Access Compliance Report

Public Rights-of-Way

(Curb Ramps)

Intersection ID: 2726	Main Street: CARDINAL_POINT_RD	Cross Street: GOLDENBLUSH_CR	Location:	N
ADA ID: 31CBBEDEDE29	Ramp Type: Perp	Initial Pass/Fail: Pass	Overall Compliance: No	Severity Score: 5
Codes/Mitigation Info/Possible Solution		Field Measurements/Component Compliance

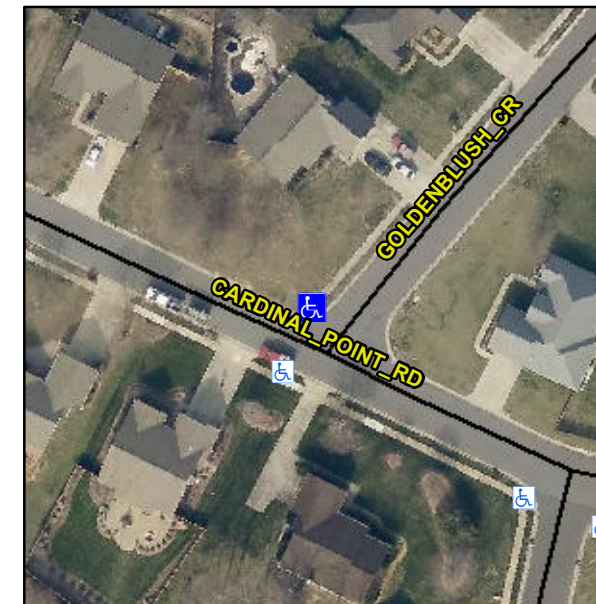
**Not Found, R304.2.1, R304.2.2-Perp,
R304.3.2-Para, R305.2, R304.5.4**

Compliance	Description	Data	Compliance	Description	Data
N/A	Ramp Length (in)	49.0	Yes	Ramp Slope (%)	5.8
Yes	Ramp Width (in)	48.0	Yes	Ramp XSlope (%)	1.0
N/A	Flare Type LT	Sloped	N/A	Flare Type RT	N/A
N/A	Flare Slope LT (%)	8.9	N/A	Flare Slope RT (%)	3.6
N/A	Flare Traversable LT?	No	N/A	Flare Traversable RT?	No
No	Landing Length (in)	46.0	Yes	DWS Provided?	Yes
Yes	Landing Width (in)	48.0	Yes	DWS Contrast?	Yes
No	Landing Slope (%)	3.6	Yes	DWS Length (in)	25.5
Yes	Landing X Slope (%)	2.0	Yes	DWS Full Width?	Yes
N/A	Landing Curb? (Y/N)	No	No	DWS Offset (in)	3.0
N/A	Shared Landing?	No			
Yes	Gutter Ponding?	No	No	Gutter Slope (%)	9.3
Yes	Gutter Lip Ht (in)	0.0	Yes	Gutter X Slope (%)	3.4
N/A	Painted X Walk1?	No	N/A	Painted X Walk2?	N/A
	X Walk 1 Direction	To SW		X Walk 2 Direction	N/A
N/A	X Walk 1 Width (in)	N/A	N/A	X Walk 2 Width (in)	N/A
	X Walk 1 Slope (%)	0.6		X Walk 2 Slope (%)	N/A
	X Walk 1 X Slope (%)	4.2		X Walk 2 X Slope (%)	N/A

N/A	Ramp inside XWalk1?	N/A	N/A	Ramp inside XWalk2?	N/A
	Road Slope (%)	N/A	N/A	Clear Space?	Yes
	Road X Slope (%)	N/A	N/A	Clear Space to XWalk (in)	N/A
Yes	Any Obstructions?	No	Yes	Storm Grate/Utility Hazard?	No
	Obstruction Type			Storm Grate/Utility Type	
		N/A			N/A
			Yes	Surface Condition? (G/P)	Good

**Remove & Replace Entire Ramp.
Remove & Replace Gutter.**
